Sadia Fashion Wears Ltd.

Talla Road, Khapur, Fatullah, Narayanganj.

04 February 2020

Observations

Gap in rafter connection

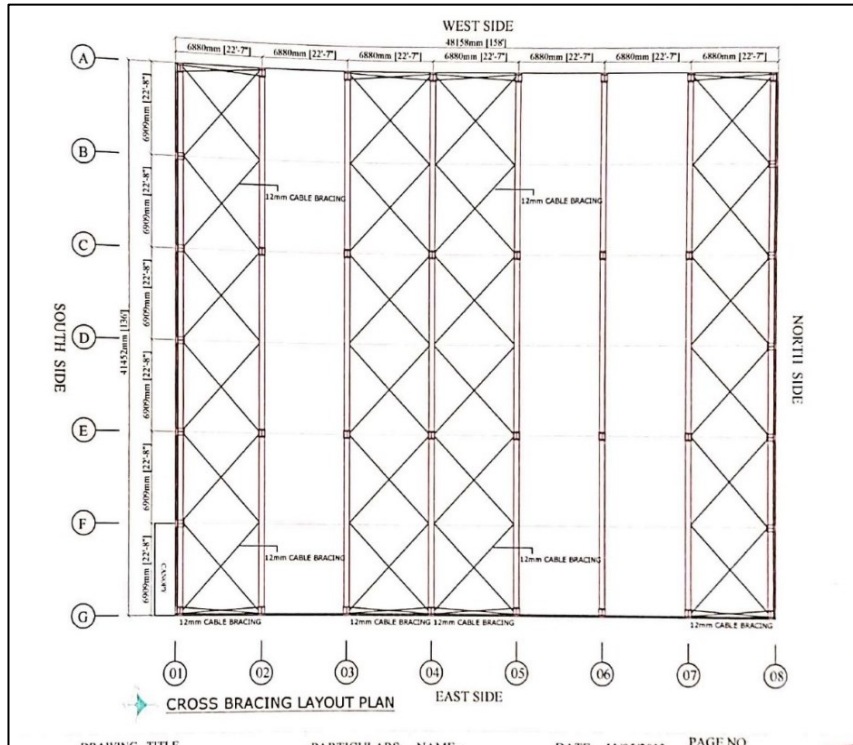
Gap in rafter connection were found in several location which may reduce the moment capacity of the connections. The building engineer is required to fill the gaps with a suitable method.

Bracing Layout Plan

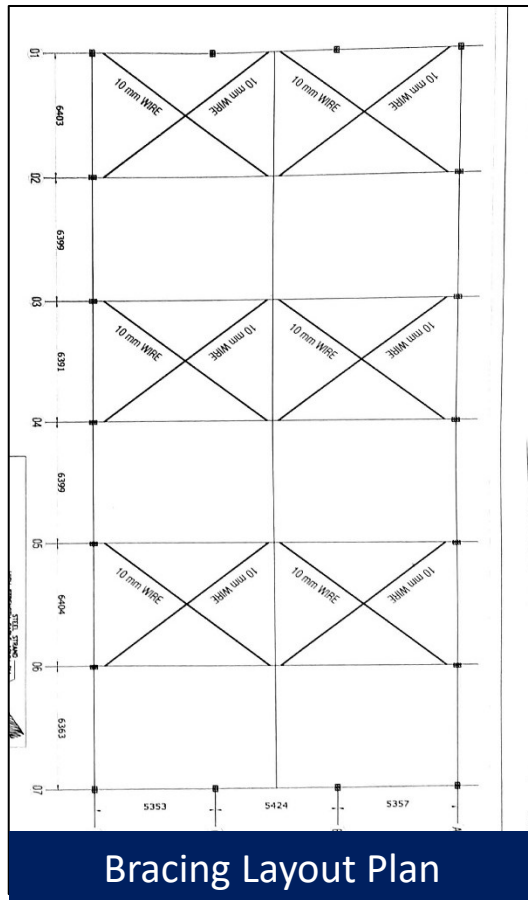
The stability system provided by tension cable bracing in wall & roof. No compression struts/members were provided in the long direction. Lack of lateral stability along the long direction is appeared. The building engineer is required to review the lateral stability system of the shed.

Absence of load transfer member in long direction
